PRODUCT CHANGE NOTIFICATION

#PCN-DC-FSG3-14

Business Unit	Product Line Code	Type of Change	Action	Date of issue
DC	ABQ	Mechanical	Notify Distributors and Field	6/05/14

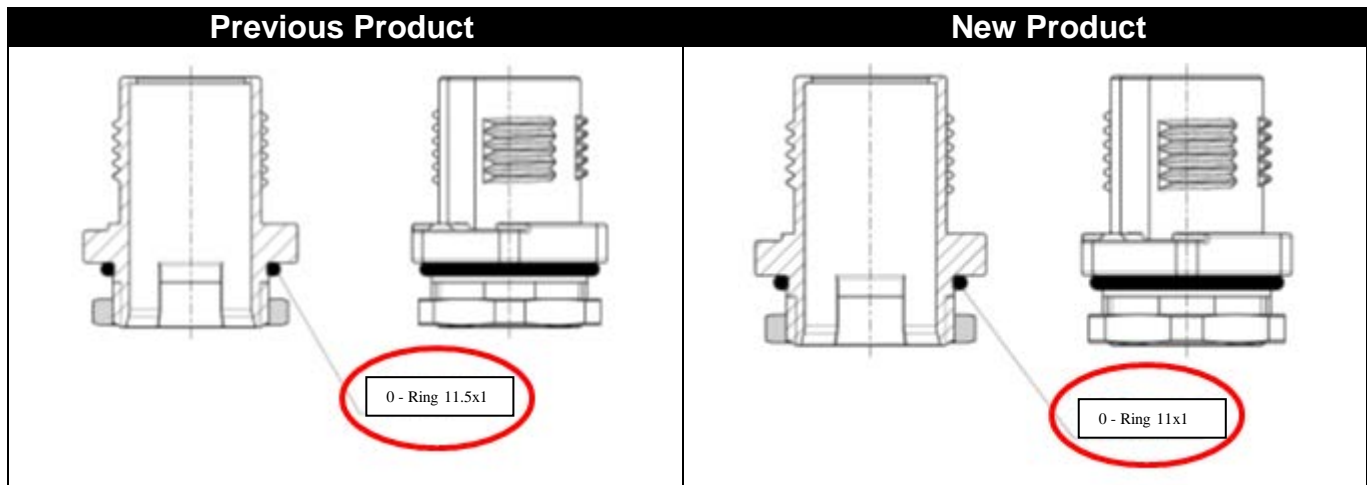
For improved position of the O-ring on the housing, the diameter of the O-ring will be changed from 11,5mm to 11mm. All performance and mounting recommendations will be unchanged.
